WRIGHT RESIDENCE
 1411 44th STREET
 SILKFAIRY, CA

P88-252

CITY PLANNING COMMISSION

PROPOSAL: The applicant is requesting the necessary entitlements to construct a nine foot high fence/wall on a street side property line.

EXHIBIT B

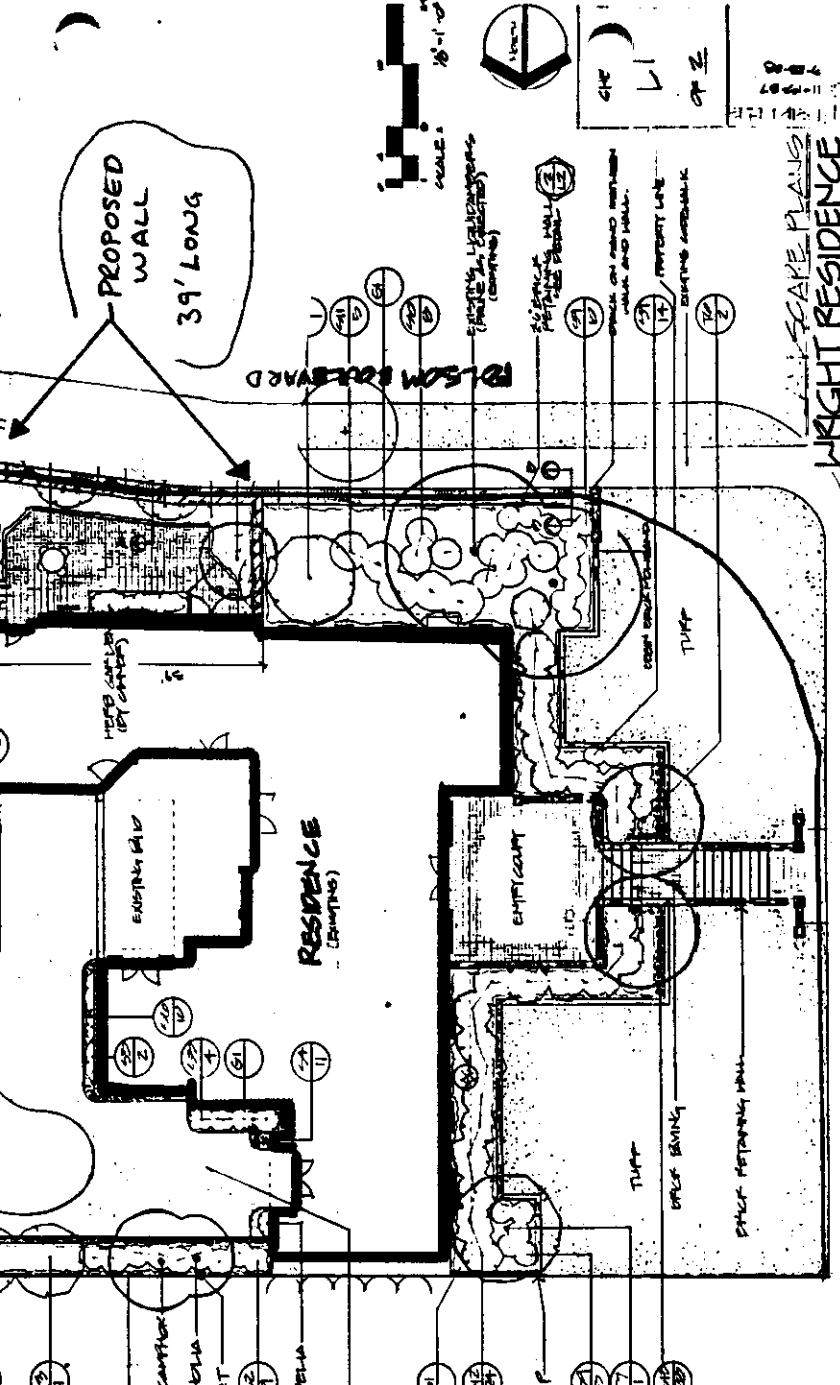
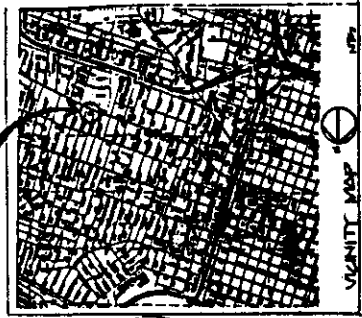
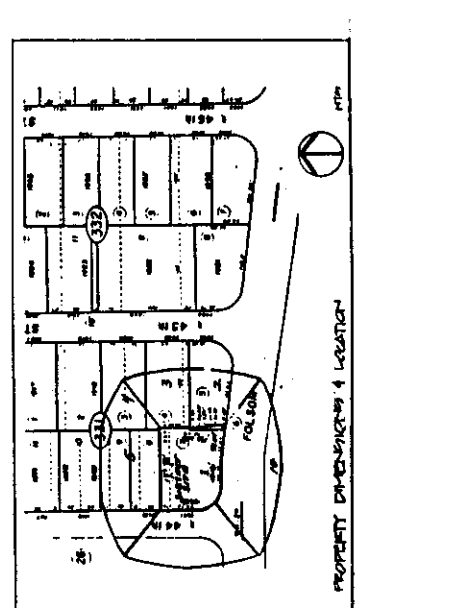
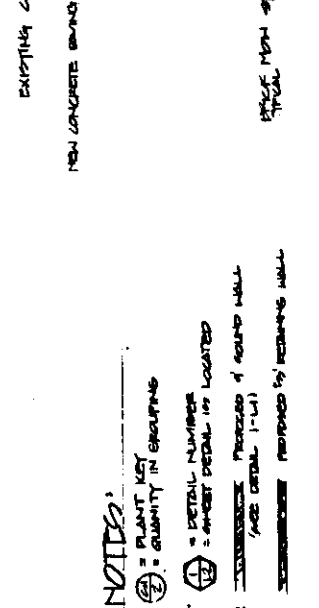
The applicant proposes a patio within a portion of the clear vision zone. The proposed plans will need to be revised to keep that area free of visual obstructions above three feet in height. This is a basic life and safety requirement of the Zoning Ordinance.

The maximum height for a fence or wall in a residential zone is six feet. Historically, Planning staff has not supported any fence variance over eight feet in height. Staff feels there is no overwhelming hardship to warrant going beyond eight feet in height.

Staff recommends a two foot setback as a compromise. The two foot setback will reduce the canyon effect described above; soften the appearance of the solid wall, and help to improve the appearance of the general area. A two foot setback will also allow the patio to be larger than it would typically be.

2. The proposed wall shall be set back two feet from the edge of the sidewalk. This area and the clear vision zone shall be landscaped, irrigated and maintained to City standards.
3. The clear vision zone shall be kept free of visual obstructions per the fence regulations of the City Zoning Ordinance.

- 1. The proposed wall shall not exceed eight feet in height from the sidewalk grade along Folsom Boulevard.
